**CABINET MEMBER FOR ENVIRONMENT – 15 NOVEMBER 2017**  
**PROPOSED TRAFFIC CALMING CHICANE B4009 CHINNOR ROAD**  
**KINGSTON BLOUNT**

**Report by Director for Structure Operations**

1. This report presents responses received to a statutory consultation on revised proposals to install traffic calming measures on the B4009 Chinnor Road at Kingston Blount.

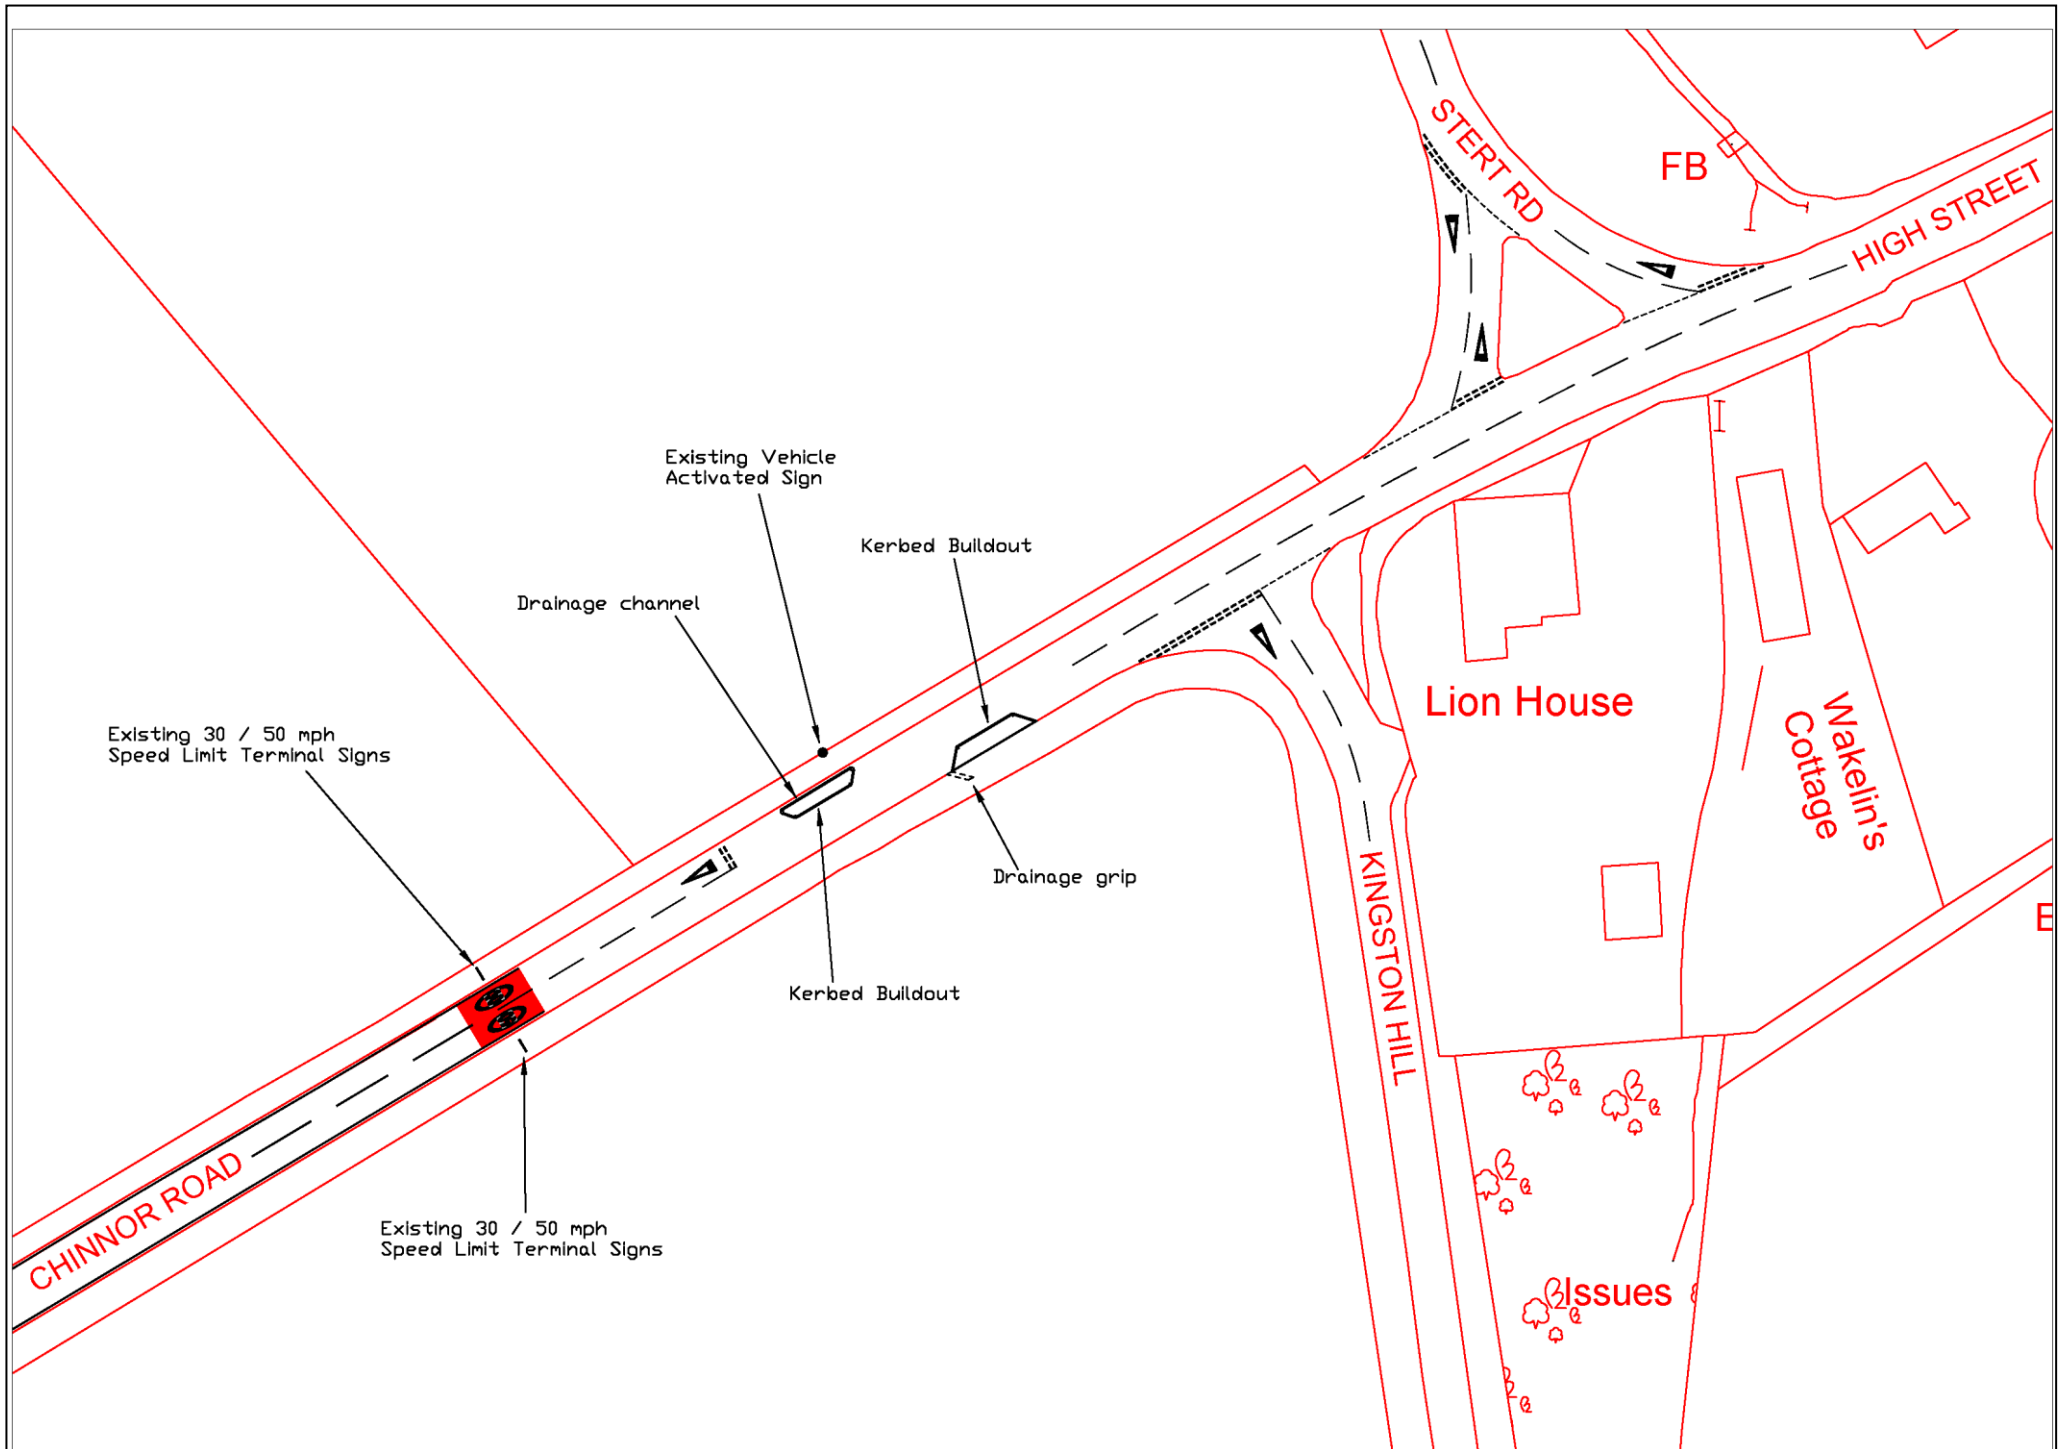
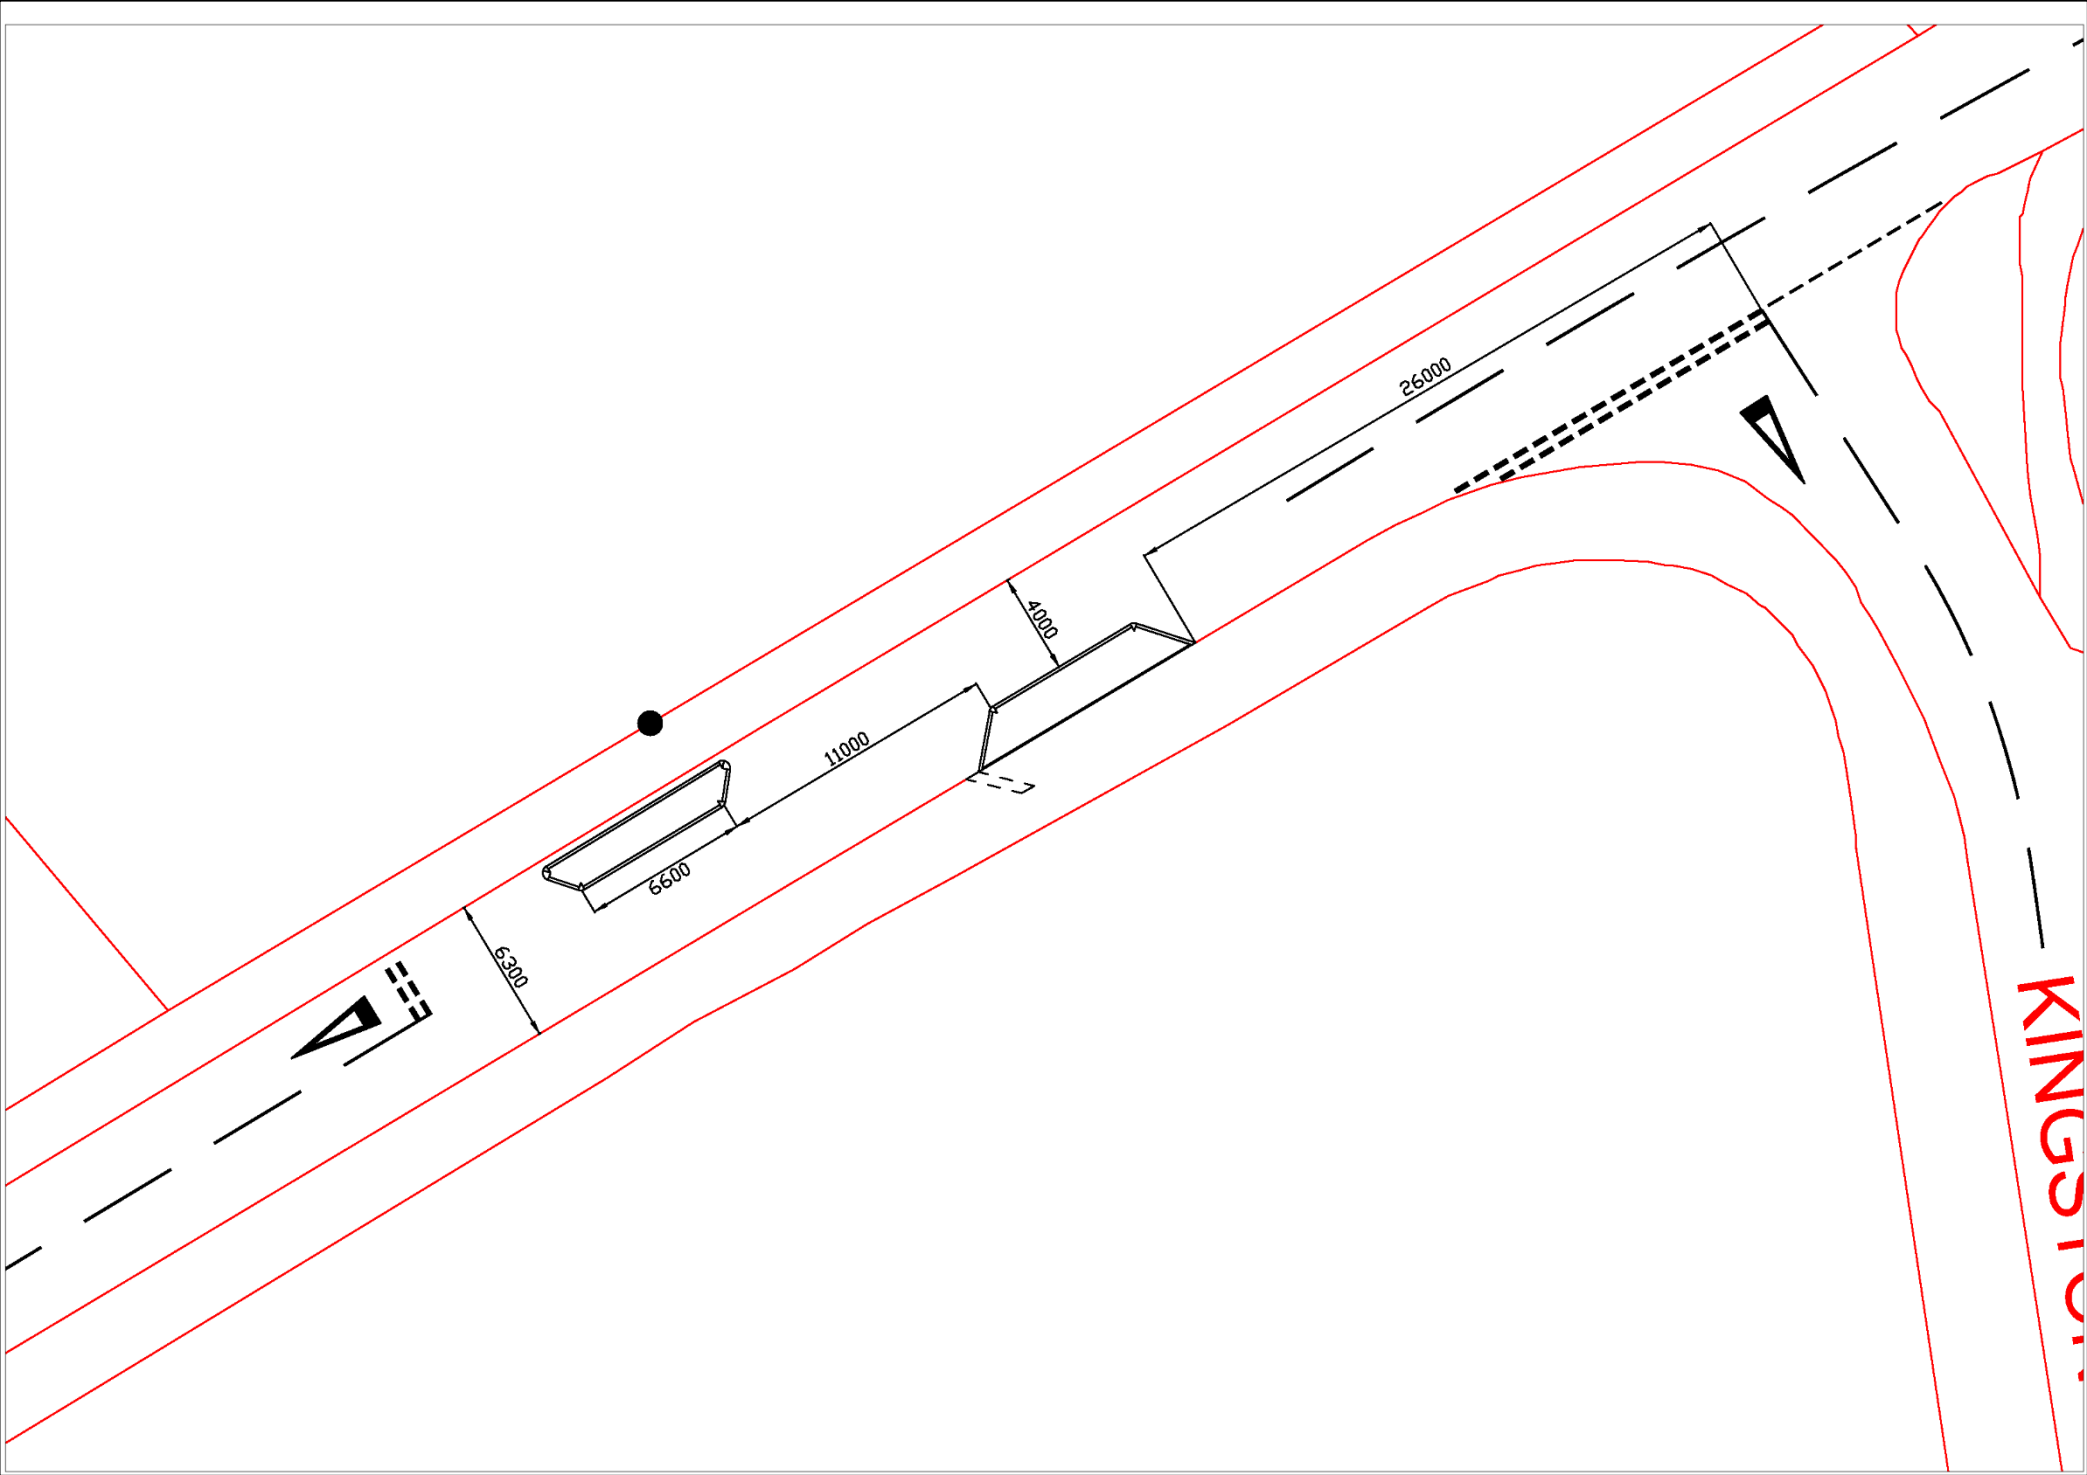
6. Four objections were received from members of the public, all residents of Chinnor on the grounds of potential traffic conflicts created by the proposed chicanes, including specific concerns over the interaction of the proposed chicane near the junction with Kingston Hill, additional traffic delays, lack of bypasses for cyclists and the lighting of the features. Wider concerns included the traffic assessments and specifically the significant traffic flows on Kingston Hill and also that the funding available for the scheme would be better spent on road maintenance.

(4) Local Resident, (Chinnor)	<p><b>Object</b> - I would be supportive of the measure. However, the use of a double chicane is questioned. Why can't the chicane currently present on the eastern end of Kingston Blount not be replicated. If the build extended further into the carriageway it would permit a cycle bypass to be introduced, whilst still permitting adequate width to pass. The presence of the westbound chicane in close proximity to the Kingston Hill turning is questioned. Finally, the poor vertical alignment for left turning vehicles from Kingston Hill along the B4009 places eastbound vehicles conflicts with each other.</p> <p>It is assumed that the chicane will be illuminated though the site of a lighting column but that would be difficult given the close proximity of the overhead power cables.</p>

(5) Local Resident, (Chinnor)	<p><b>Object</b> - Some points to note:</p> <p>1: does it show that 30 mph illuminated signs do not work?</p> <p>2: OCC's knowledge of traffic in the area. There are count points on the B4009 at Aston Rowant, CP069, and just out of Chinnor village towards the Henton turn, CP182, which is used to measure the B4009 through traffic for Chinnor. Unfortunately planning applications use the census data for travel to work which shows that well over 50% of vehicles exit via Crowell Road with 20% heading out of the village towards the Henton end but the Kingston Blount CP shows far less than the Henton one (it has been stated that the B4009 is only at 60% capacity, but far higher counts would be</p>

<p>(7) Local Resident, (Kingston Blount)</p>	<p><b>Support</b> - It seems after 3 attempts, OCC highway engineers have put the chicane where I said it should go in first place, near the bottom of Kingston Hill.</p> <p>This might solve the problem of cars from the M40 speeding, if they have to stop, but it doesn't deal with the speeding between the Cherry Tree and Icknield Close, where there have been more accidents than at the junction of the Hill and the Stert. I installed the VAS's which with the chicane are effective for 80% of the time, but not for the other 20% who are idiots. Also the B4009 is very narrow at top of Pleck Lane, I have sent you video to prove this, which needs to be addressed.</p> <p>You need to have two raised areas to physically slow vehicles down between the Cherry and Icknield Close. They seem to have these areas all over Europe but not in Oxfordshire. Aston Rowant needs calming, raised areas are the answer, chicanes won't work. The prediction is of 11,000 vehicles a day by 2022, 7500 now for the B4009.</p>

7. While it is acknowledged that traffic calming features of this type can result in additional delays this has to be balanced against the benefits to residents of the village in particular. The trial layout at peak times indicated that the proposed layout did appear to assist in reducing traffic speeds without causing undue queuing. A safety audit of the detailed design has been arranged that will include specific consideration of the concerns raised in respect of queuing and the interaction of traffic at adjacent junctions, together with the conspicuity of the chicanes in darkness and provision for pedal cyclists.
